Penrith Waste Recycling and Transfer Facility Modification 1

Change in building material
State Significant Development Modification Assessment
(SSD 7733 MOD 1)

May 2021

Published by the NSW Department of Planning, Industry and Environment

Figure 2 | Approved plan for the western elevation showing parts of external walls in Colorbond cladding

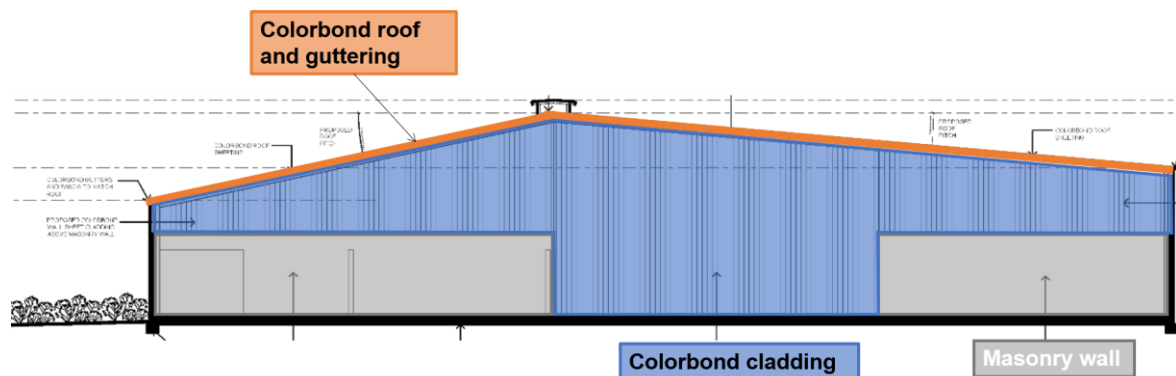
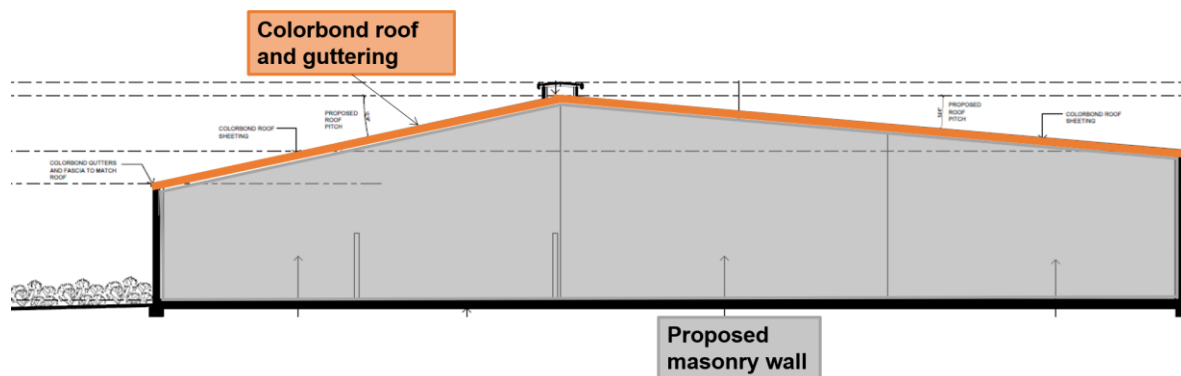
The modification application seeks to change the building material used for the external walls of the large building. The current approved design includes masonry walls for some parts of the external walls and Colorbond steel cladding for other parts. The exact approved wall material configuration (i.e. the split between masonry and Colorbond) varies between the north, south, east and west elevations.

The modification proposes replacing all Colorbond wall sections with masonry to provide full-height masonry walls on all sides which would increase the overall FRL of the building. See **Figure 2** and **Figure 3**. The increased FRL would represent a reduced risk of any fire spreading to nearby buildings and, in turn, increase the safety of the occupants of these buildings as well as the safety of fire fighters.

Findings	Recommendations
Fire Safety	
<ul style="list-style-type: none"> • Waste facilities generally present a “special problem of firefighting”. During the assessment of SSD 7733, FRNSW required the Applicant to address Clauses E1.10 and E2.3 of the National Construction Code (NCC) and recommended ongoing engagement with FRNSW to ensure its requirements would be met. • The Applicant indicated fire safety measures would be finalised as part of the detailed design process for the facility, including the large building, and confirmed appropriate fire measures would be included. Hence, conditions of consent required the final design of the onsite fire safety systems to meet the relevant requirements of the Building Code of Australia (BCA). • Following the consultation with FRNSW required under condition B36 of SSD 7733, FRNSW required the Applicant to re-design the building to meet the relevant structural and fire safety requirement including a higher FRL for the building. • A higher FRL would be achieved by altering the construction material of the external walls of the building to be masonry. Masonry is considered a non-combustible building material. • FRNSW was supportive of the increase in FRL facilitated by the modification. • The Department considers that increasing the FRL of the building is desirable and required to increase safety and satisfy FRNSW. • The Department is satisfied the modification would ensure fire safety is improved on the site and recommends the plans in Appendix 1 of SSD 7733 be updated to show the changes in the external walls of the building. 	<ul style="list-style-type: none"> • Update the Development Layout Plans in Appendix 1 of SSD 7733 to show full height masonry walls.
